City of Oxford
Community Development Department
STAFF REPORT

Board of Zoning Appeals

Case # BZA-08-2012

Applicant:	Scott Webb, Architect
Location:	201 East Chestnut Street
Owner:	Ashley at Chestnut, LLC (Bart Werpin, Manager)
Potential Buyer:	GMS Development (Guy Totino)
Action Requests:	Variance to Occupancy reduction 1137.08(e); Multiple buildings on a lot 1141.03(a); Front yard setback 1143.06(c)(2)(A); Lot coverage 1143.06(c)(4)(A)(1); Parking spaces 1149.03(e); Parking setback 1149.04(3); Parking islands 1149.05(e)(4)(F); Parking trees 1149.05(e)(5)(B)(1)(a); Perimeter screening 1149.05(e)(4)(B)
Current Use:	3 story multi-family residential
Zoning:	R-3, Multi-Family
Surrounding Land Uses:	Single and Multi-Family Residential

EXISTING SITE PLAN
DIMENSION PLAN
1" = 30'-0"

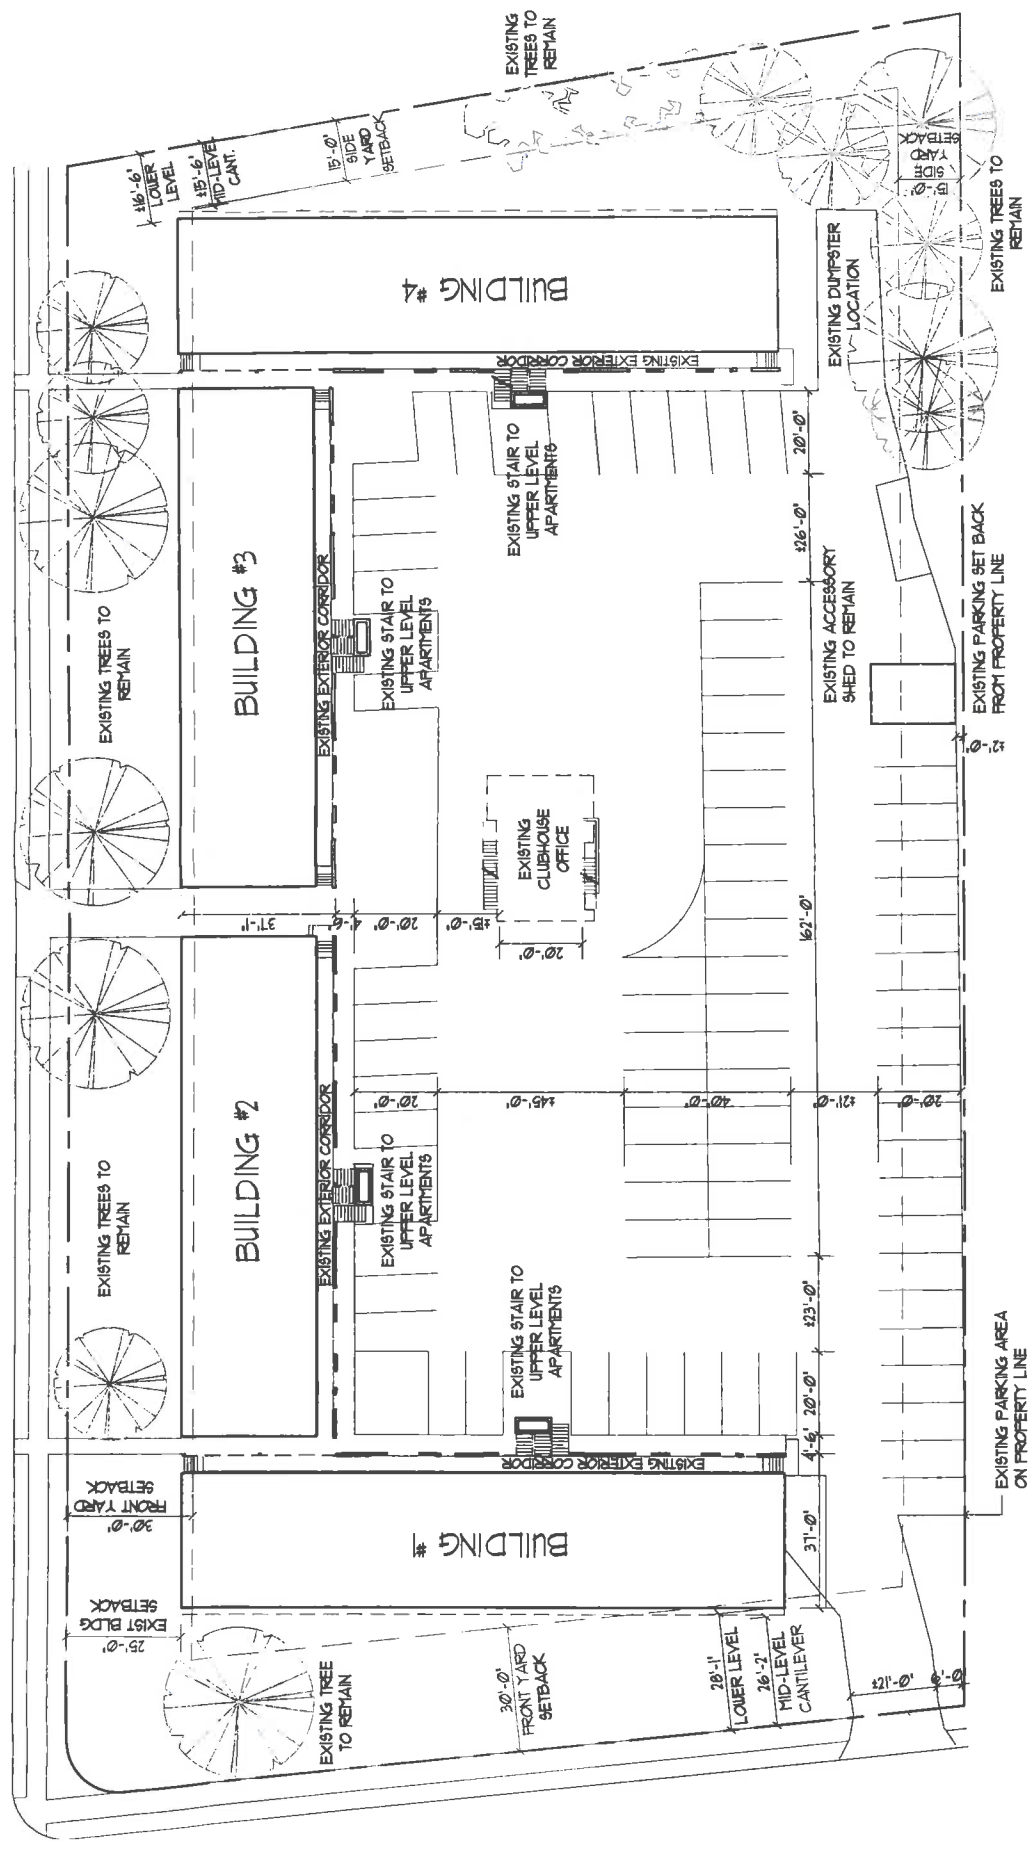
The front yard (setback) requirement when the buildings were built may have been 25 feet, which the buildings would comply with. However, the current requirement for the R-3 district is 30 feet. As shown on the attached site plan, nearly the entire façade encroaches into the front yard by 5 feet. The lower level is stepped back about two feet further away from the street than the upper two levels. The applicant is proposing to use the existing building shells, which are nonconforming, therefore is requesting a variance of 5 feet for the majority of the façade, with the exception of just the far

southwest corner, which is nonconforming by 8 feet.

A slight reduction in lot coverage is proposed (72.1% to 70.3%). However, this is still far from compliance with the current maximum of 35%.

It is not clear what the zoning requirement was at the time of construction of these buildings. However, current requirements would require 195 parking spaces. A reduction from 78 units to 44 units would require 110 parking spaces. However, the applicant is proposing to use the existing paved area as well as create some new interior landscaping. This approach would allow only 89 parking spaces, which is 21 less than required.

The existing paved parking area along the south property line tapers to well below 3 feet.

The existing site has no interior landscaped islands. The proposed island is possible because of the removal of the common-use building in the center of the parking lot. Based on the number and location of rows of parking, at least 6 separate islands are required. Only one very long island is proposed.

The intent of the tree requirement is to have some parking lot landscaping within the parking area and directly adjacent. This breaks up extensive hard surfaces and adds to the general health and welfare of the area. The proposal adds trees (7) to the parking area, where possible, but does not meet the full requirement of 18 trees.

The existing and proposed parking spaces along the south property line are situated in such a way that cars which pull in, could have headlights projecting into the residential structures to the south. No screening is proposed by the applicant.
